# PLAR26-00059– 417 Nassau Street

## Staff Report

<b>Address:</b>	417 Nassau Street
<b>Request:</b>	Certificate of Architectural Compliance (CAC) for a new addition along the rear of the house
<b>Owner/Applicant:</b>	Samuel and Anna Mclean Joynson
<b>Agent:</b>	Sam Hardie, AIA of Beebe Design Studio
<b>Parcel ID:</b>	0429-04-0023
<b>Architectural Control District:</b>	Historic Venice
<b>Application Date:</b>	February 20, 2026

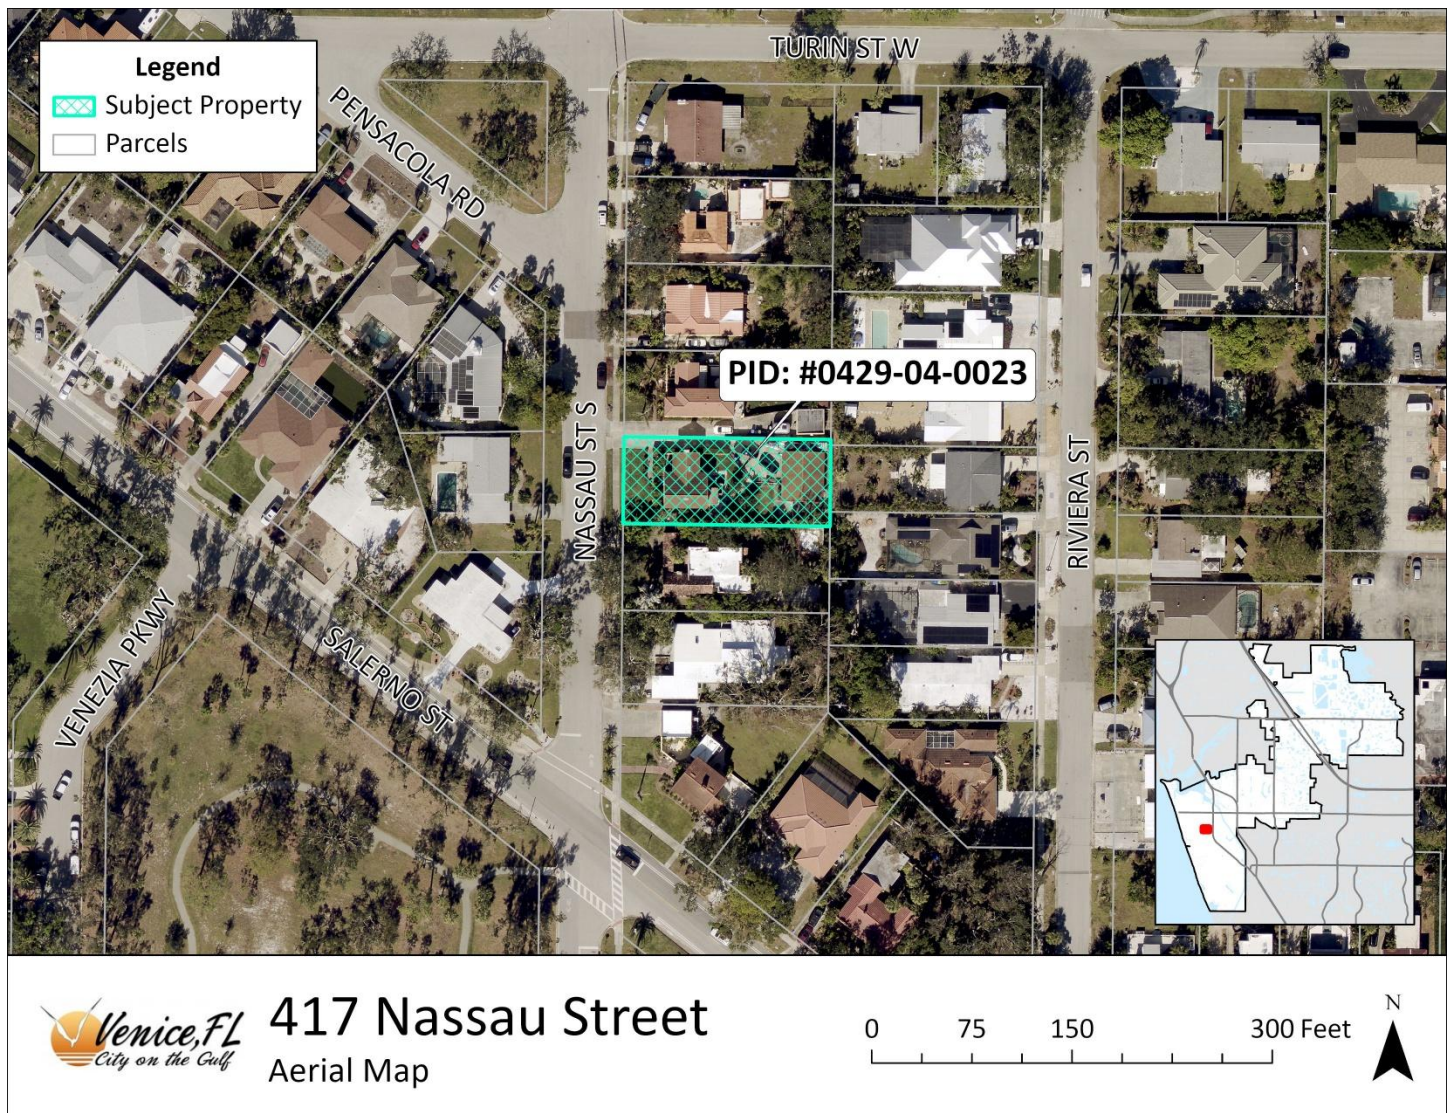
This proposal greatly alters the spatial relationship between the original home and the garage.

It is not clear if the doors and windows that will be replaced are original or in a grossly deteriorated state.

The addition to the building, although in the rear, challenges the scale, proportion, and massing of the original structure. The application does not demonstrate how the new construction will be differentiated from the original structure.

The addition does not appear that it could be removed without impairing the integrity of the building.

***Applicant Response:** While there does appear to have been an original carriage house, the existing detached garage on the property does not appear to be original or it has been substantially altered. The proposed addition on the rear of the existing house is closer to the existing detached garage, however the proposed spatial relationship is similar to other houses with detached carriage houses in the VHP.*

***Applicant Response:** The existing doors and windows not original or historic and will be replaced with new impact windows and doors. Additionally, the existing doors and windows were installed to the outside face of the existing exterior walls. New hurricane impact windows will be installed mid wall with stucco returns to create a shadow line as typical in the VHP.*

***Applicant Response:** The new addition is to be placed at the rear of the original house so as not compete with the original facade. The additional is slightly taller than the existing roof line and the intersection of roof lines occur at the rear of the property. There are no continuation of existing wall into the addition in order to have clear differentiation from original to new.*

***Applicant Response:** The proposed addition will be structurally independent from the existing residence and therefore could be removed entirely without impairing the integrity of the building.*
